Panhandle Energy

**RE: CPF 2-2009-1004W (September 23, 2009 PHMSA Letter)
Response to Warning Letter**

WARNING LETTER

CPF 2-2009- 1004W

INITIAL CORROSION SURVEY SHEET

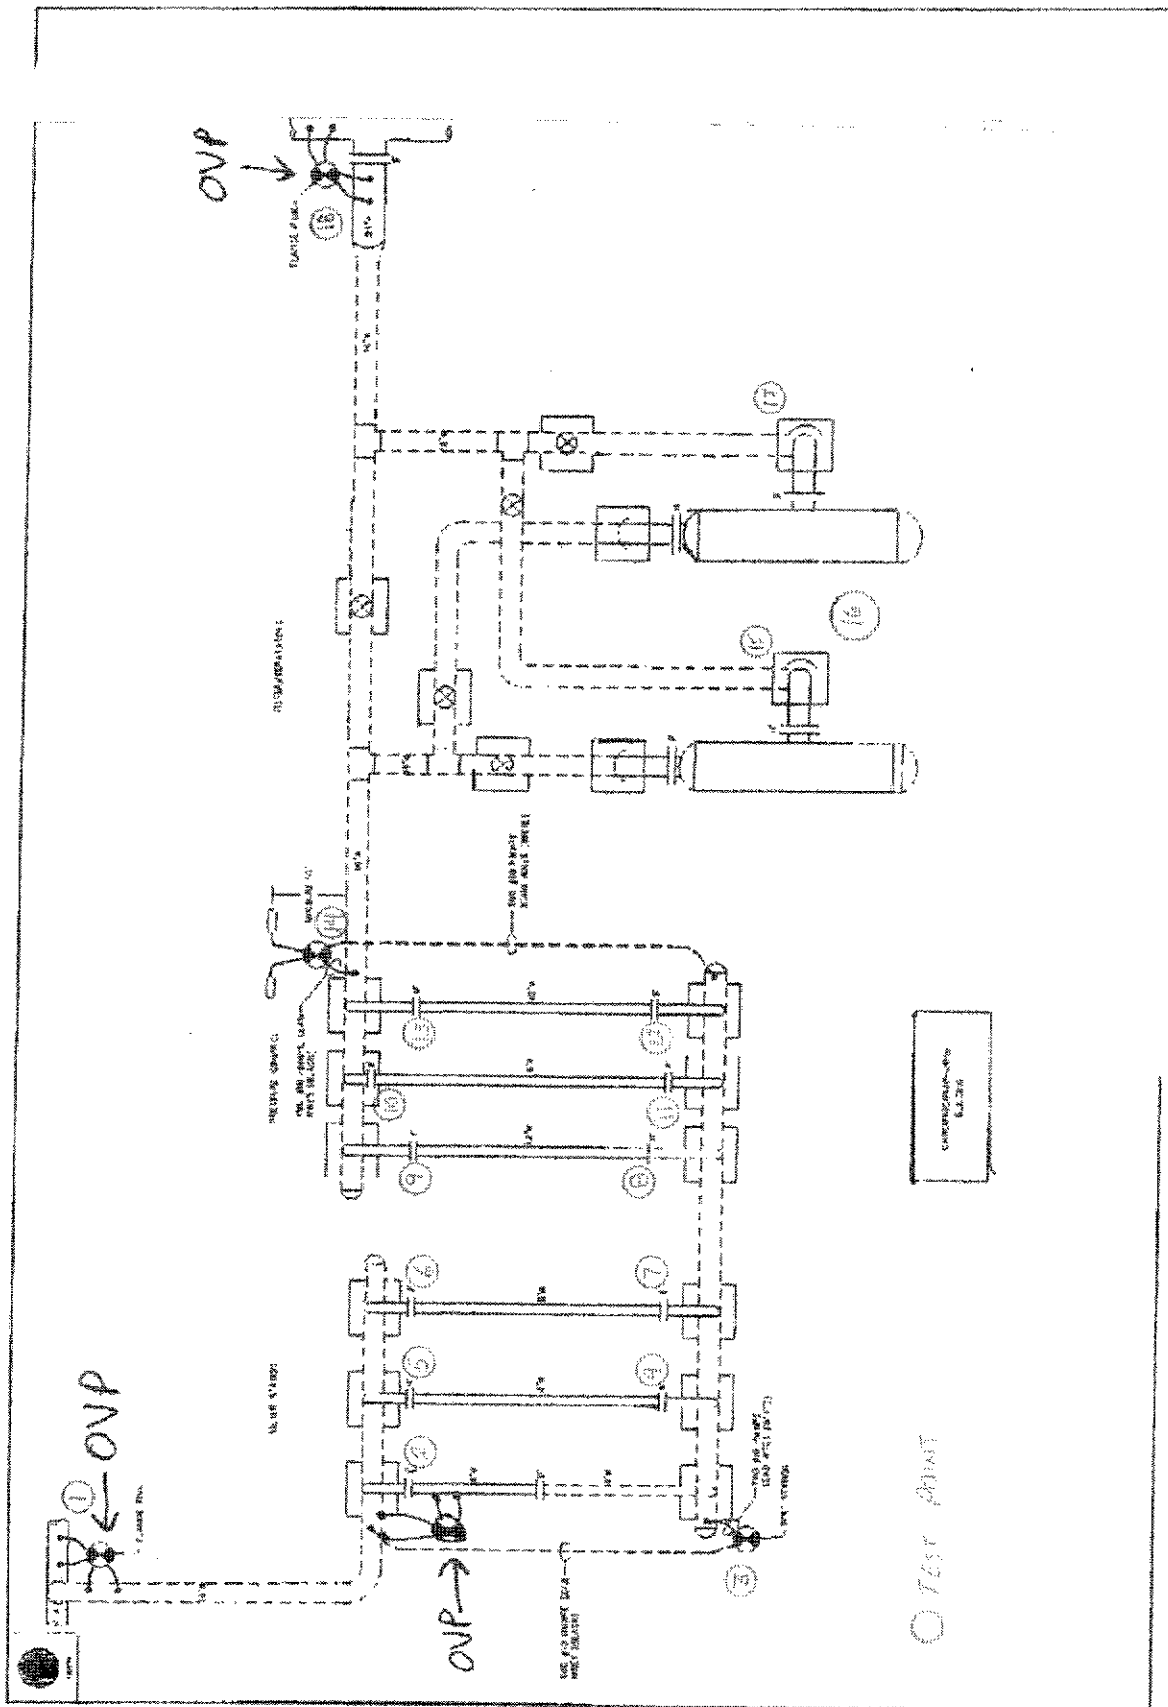
The Caryville team missed the 15 month interval requirement on the 100 line at mile post 27.678 (test point 146139) "Valve at the Smith Power plant". Pipe to Soil Readings were taken on 3/6/08 and 8/5/09.

Regarding test point 146139, FGT agrees that the noted information was not available in the FGT's system at the time of the audit. FGT has enclosed documentation of a reading taken on May 9th by the Smith Plant Technician and witnessed by the FGT's OQ-qualified technician.

Peter, this email is to confirm with you that the readings in question that I sent to Nathan on October 8, 2009 were taken on May 9th 2008, and were taken by Nathan Smith and myself at Plant Smith
